Peter E. Katz
Vice President
Calvert Cliffs Nuclear Power Plant
Constellation Generation Group, LLC

May 28, 2003

SUBJECT: Calvert Cliffs Nuclear Power Plant
Unit Nos. 1 & 2; Docket Nos. 50-317 & 50-318
License Amendment Request: Revision to Technical Specification P-T Curves

Figure 3.4.3-2
Calvert Cliffs Unit 1 Cooldown Curve, for Fluence $\leq 4.49 \times 10^{19}$ n/cm²
Reactor Coolant System Pressure Temperature Limits

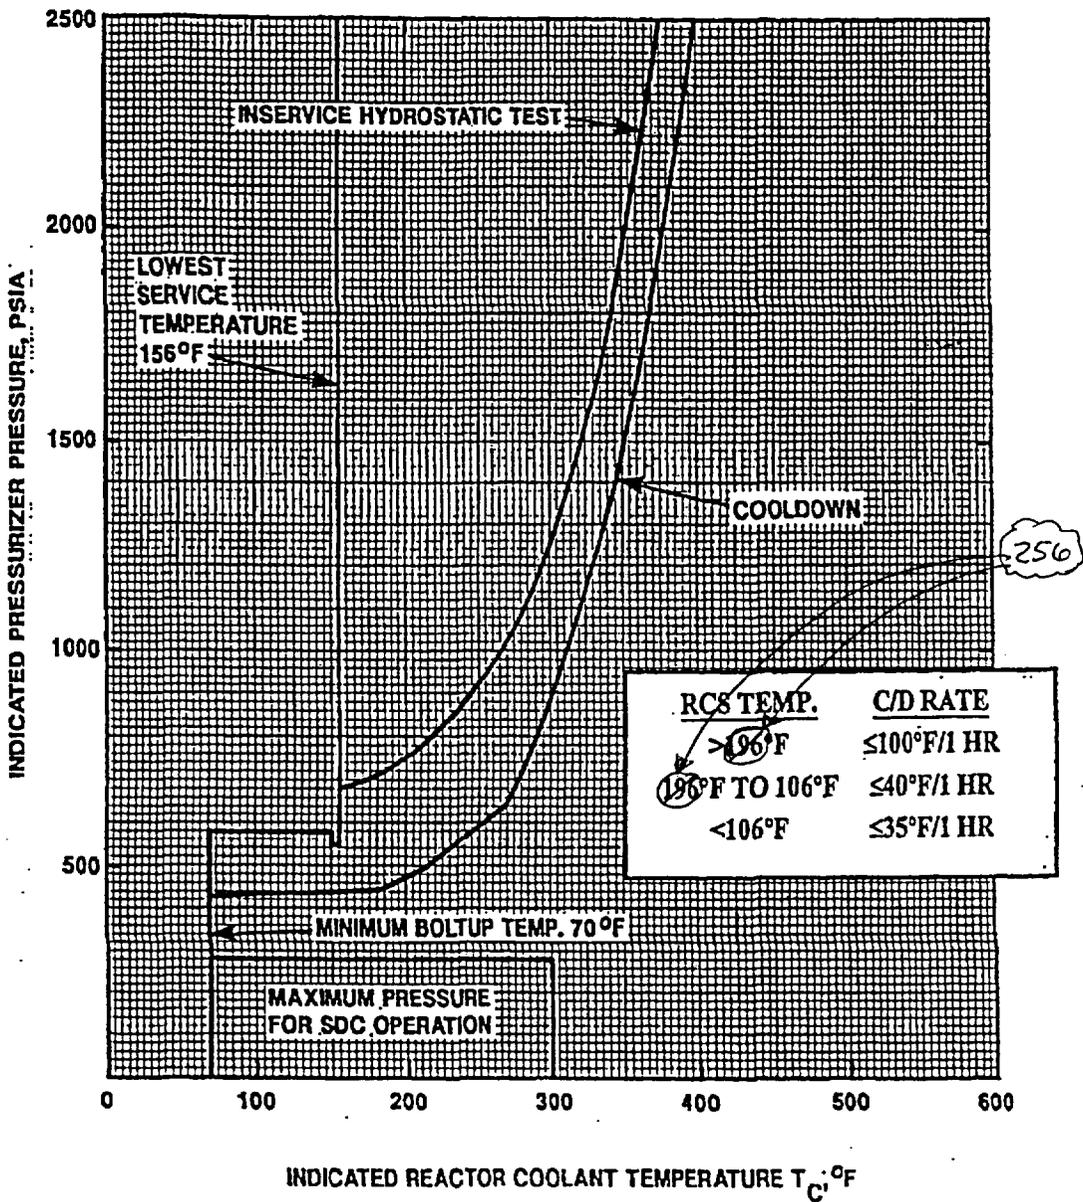
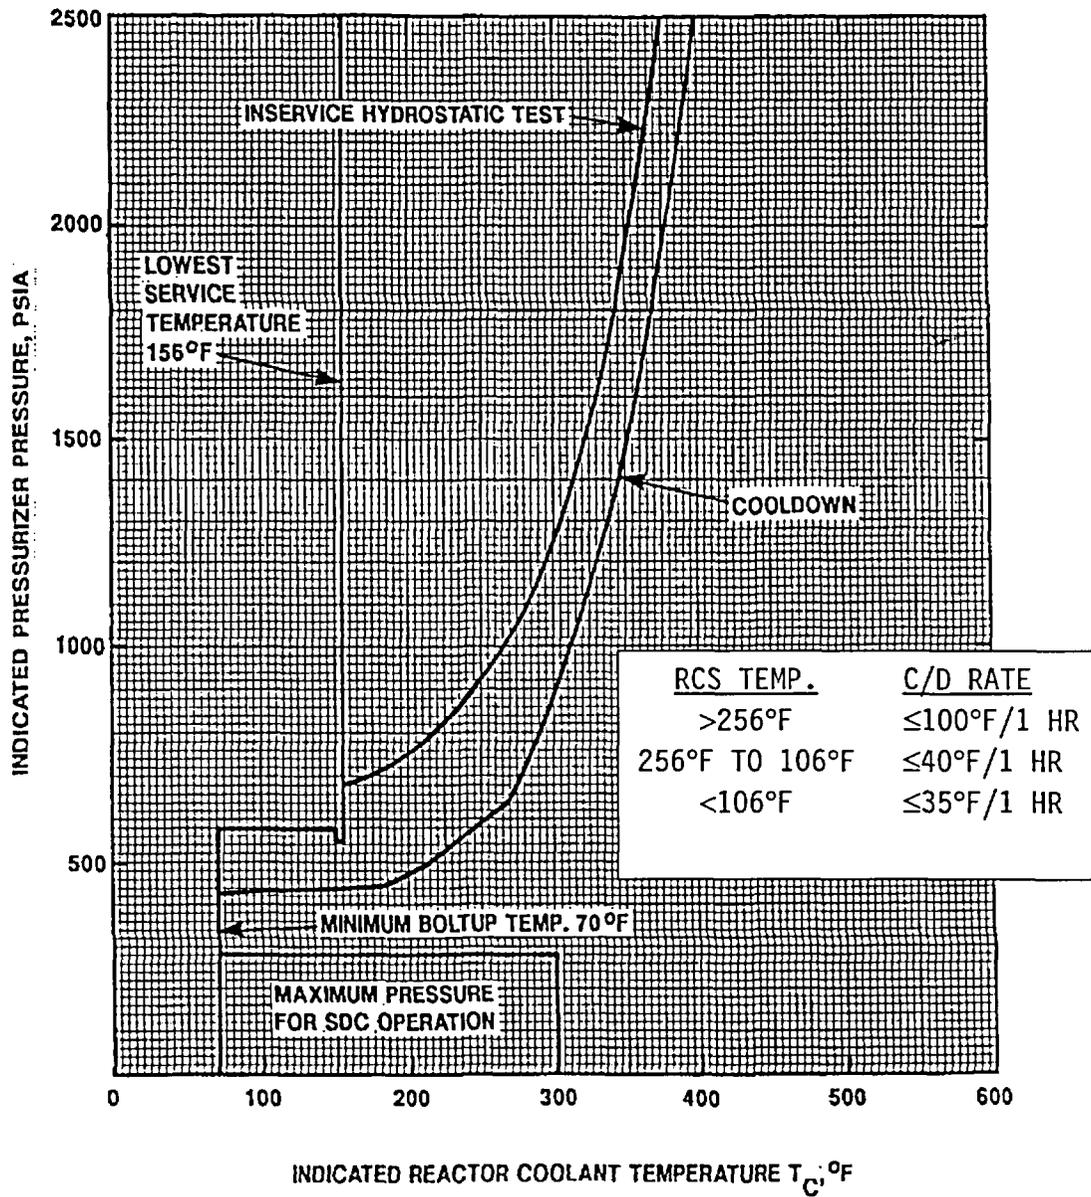
The proposed amendment revises the Unit 1 and Unit 2 cooldown curves [Technical Specification Figure 3.4.3-2 (2 pages)] to change the range of temperatures for which a cooldown rate of 100°F/hr is acceptable.

Revise Technical Specification Figures 3.4.3-2 (Unit 1) and 3.4.3-2 (Unit 2) as shown in the marked-up Technical Specification pages in Attachment (1). The final Technical Specification pages are provided in Attachment (2).

This proposed amendment revises the Unit 1 and Unit 2 cooldown curves to change the range of temperatures for which a cooldown rate of 100°F/hr is acceptable. The change in range resulted from an evaluation of a cooldown in which residual stresses from the 100°F/hr rate affected the stress during the cooldown at the 40°F/hr rate.

The proposed change only changes the temperature at which the cooldown transitions from 100°F/hr to 40°F/hr. It does not change the basic cooldown rates or methods of cooling down the Reactor Coolant System. This cooldown transition does not affect the probability of an accident previously evaluated because the cooldown rates have not changed. Additionally, since the cooldown rates are not changed above 300°F, the safety analyses and dose consequences in the Updated Final Safety Analysis Report are not affected.

from the history of the transient. This proposed amendment will further limit the allowable thermal stress intensity factor during cooldown to reflect the persistence of thermal stress from higher cooldown rates following transition to lower cooldown rates. Further limitations in allowable thermal stress intensity factor requires an increase in the changeover temperature from higher to lower cooldown rates.

In order to maintain current LTOP setpoints, it is necessary to define the new cooldown rate range (the temperature at which it is required to change the cooldown rate from 100°F/hr to 40°F/hr) such that the pressure necessary to create the maximum K_{IM} is equal to or greater than maximum allowable pressure for the existing LTOP limits. It is important to note that the new temperature range will not permit operation at higher pressures (K_{IM}) than permitted previously. Instead, pressure will be limited in the new curves to the same value it was limited to in the old curves.
